COMMENTS	RESPONSES
<p style="text-align: right;">Comment Letter I39a</p> <p>June 20, 2017 Michelle Irace Planning & Development Services County of San Diego 5510 Overland Avenue, Suite 310 San Diego, CA. 92123 Re: Harmony Grove Village South (HGVs) Draft Environmental Impact Report PDS2015-GPA-15-002, PDS2015-SP-15-002, PDS2015-REZ-15-003, PDS2015-TM-5600, PDS2015-MUP-15-008, PDS2015-ER-15-08-006 Dear County of San Diego,</p> <p>Background: The following is the general description of the project from chapter 1.0:</p> <p>"1.1 Project Objectives The purpose of the Harmony Grove Village South Project (hereafter referred to as "Proposed Project," "Project," or "HGV South") is to expand the contiguous Harmony Grove Village (HGV) to include a residential component that provides a mix of residential opportunities, and community center/limited commercial opportunities that complement existing elements of HGV and contribute to the overall functioning of the village as a whole. Integral considerations are to provide a pedestrian-oriented sustainable community that complements the natural environment, protects the community character, and integrates the residential, recreational, and public u

Figure 4

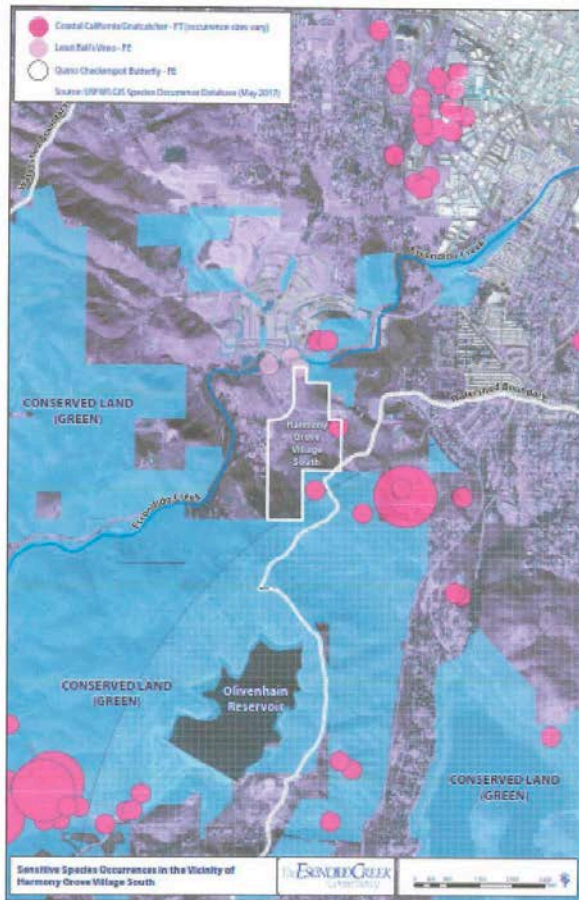
I39a-3

Figure 8 (Snapshot of Figure 3.1.2-1)

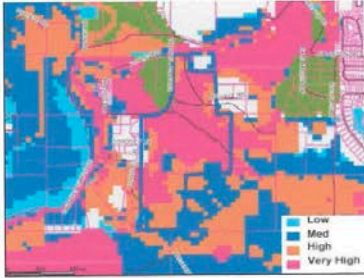
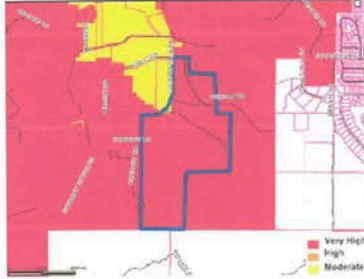
I39a-7

Figure 11

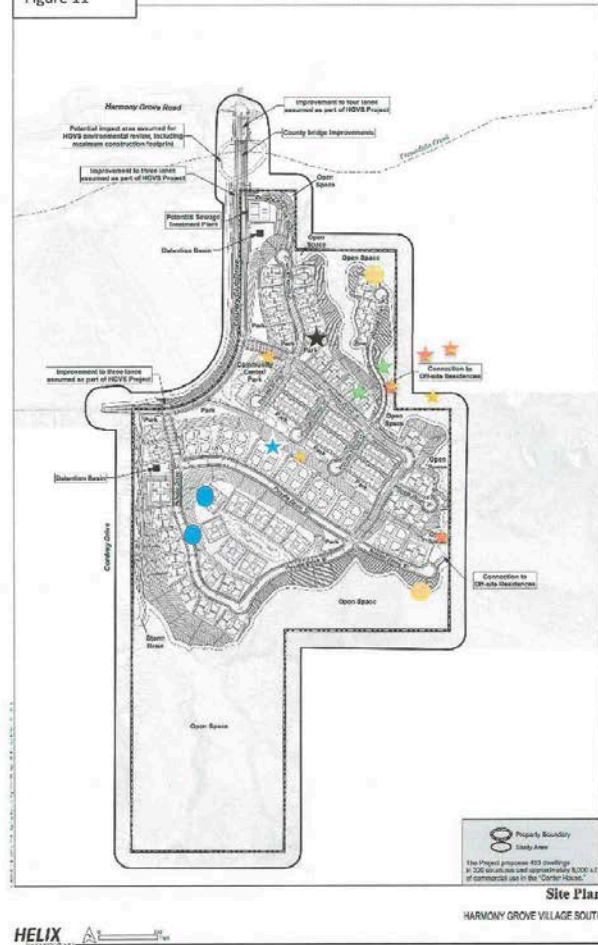
In addition I have photographed and videoed other species on site which are listed below and marked on Figure 11.
